Part Number: A054H094					3D image provided when available for visual reference only.	
	Change Notice	CN00114424	Alternates				
	Manufacturer Part (MEP)	No	Usage	Production and Service			
	Release Phase Code	Production (P)	Drawing Specification	Number: A054H094_DET			
	External Regulations	No External Regulation		Revision: G			
Associated Specifications							
Number	Title	Type	Category	Sub-Category			
10903	Substances,Prohibited and Restricted	Engineering Specification	Administrative Specification	Source Control

Drawing Revision Information							
Description of Change(s) Note: Change information is provided for reference only and does not supersede the drawing's primary content.

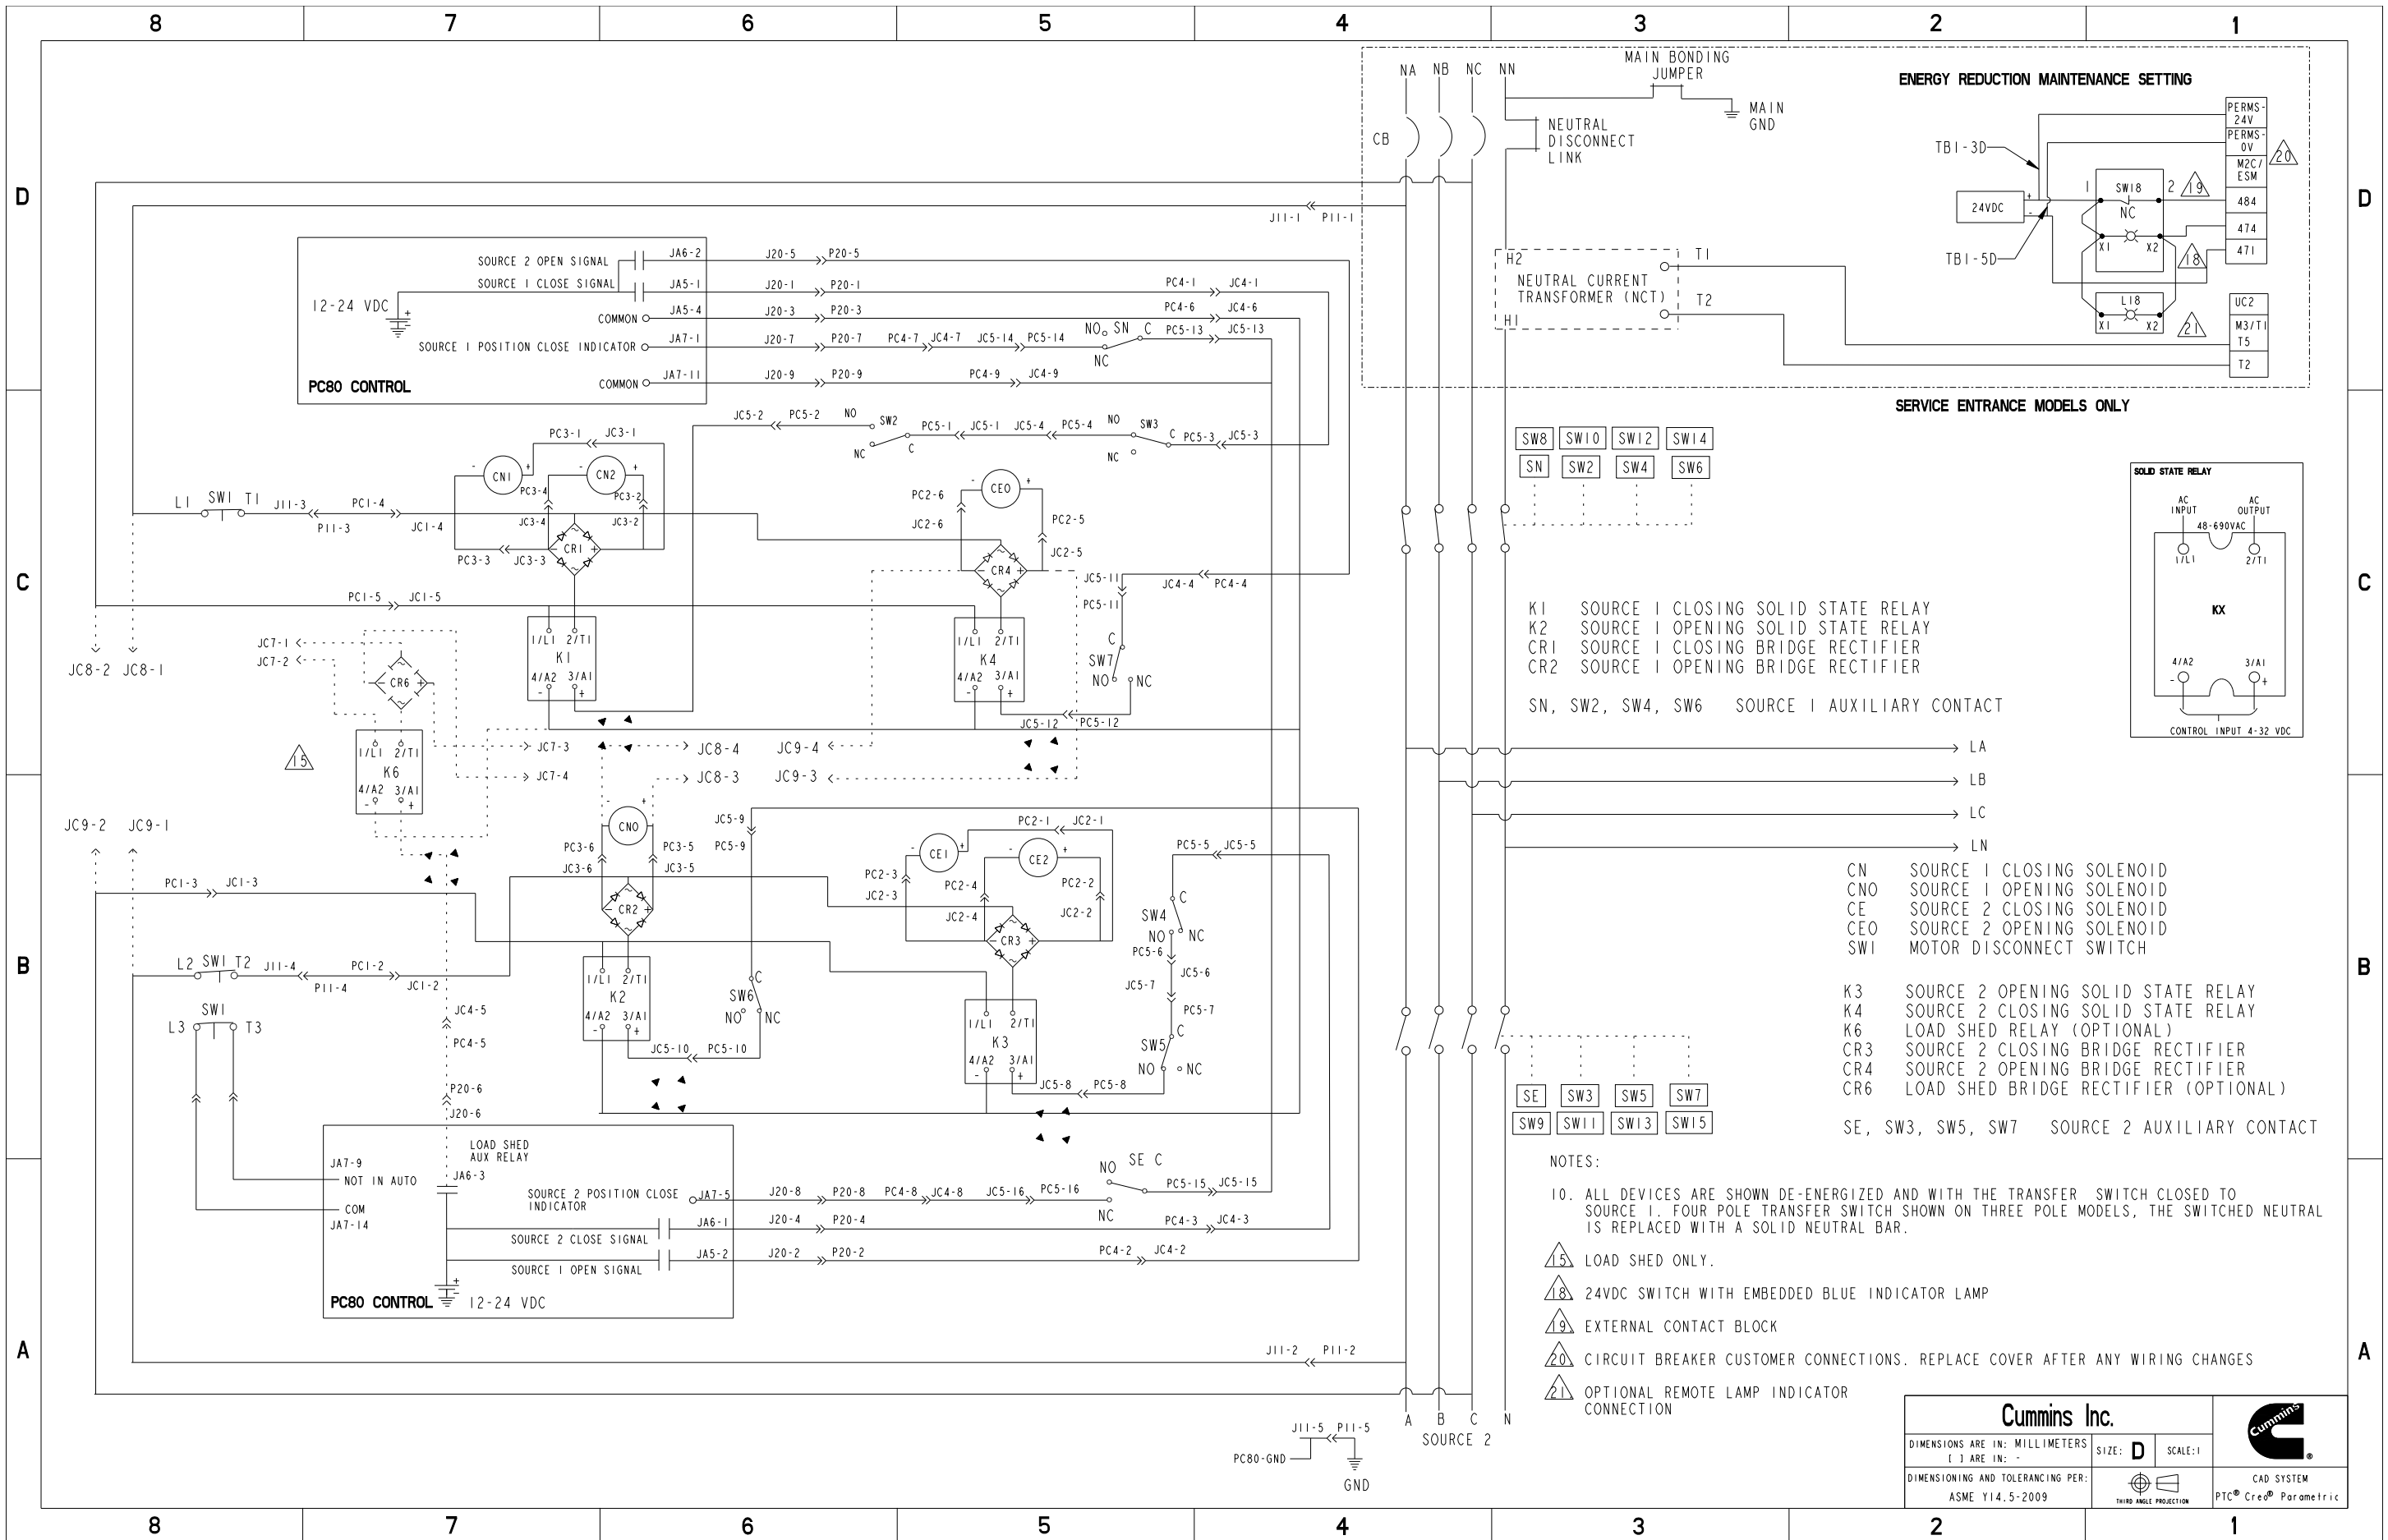
SHEET 1 1. NOTE 16: "SEE SHEET 4" WAS "FOR NON-AUTOMATIC APPLICATION ONLY. SHOWN WITH SWITCH CONTACTS CONNECTED TO LOCAL ON SW16 AND SW17 IN NEUTRAL POSITION?" 2. NOTE 17: "SEE SHEET 3" WAS "SPD OPTIONAL. IF INSTALLED, REFER TO A058L134 FOR SCHEMATIC" 3. NOTE 18: "SEE SHEET 5" WAS "24VDC SWITCH WITH EMBEDDED BLUE INDICATOR LAMP" 4. NOTE 19: "SEE SHEET 5" WAS "EXTERNAL CONTACT BLOCK" 5. NOTE 20: "SEE SHEET 5" WAS "CIRCUIT BREAKER CUSTOMER CONNECTIONS. REPLACE COVER AFTER ANY WIRING CHANGES" 6. NOTE 21: "SEE SHEET 5" WAS "OPTIONAL REMOTE LAMP INDICATOR CONNECTION" SHEET 3 7. ADD NOTE 17 8. ZONE D6: TB1-23D WAS TB1-24D 9. ZONE D7: TB1-24D WAS TB1-23D SHEET 4 10. ADD NOTE 16 11. ZONE B6: PA13-2 WAS PA13-20 12. ZONE B6: PA13-20 WAS PA13-2 SHEET 5 13. ZONE D1: UPDATED ENERGY REDUCTION MAINTENANCE SETTING WIRING CONNECTION 14. ADD NOTES 18 19, 20 AND 21 .
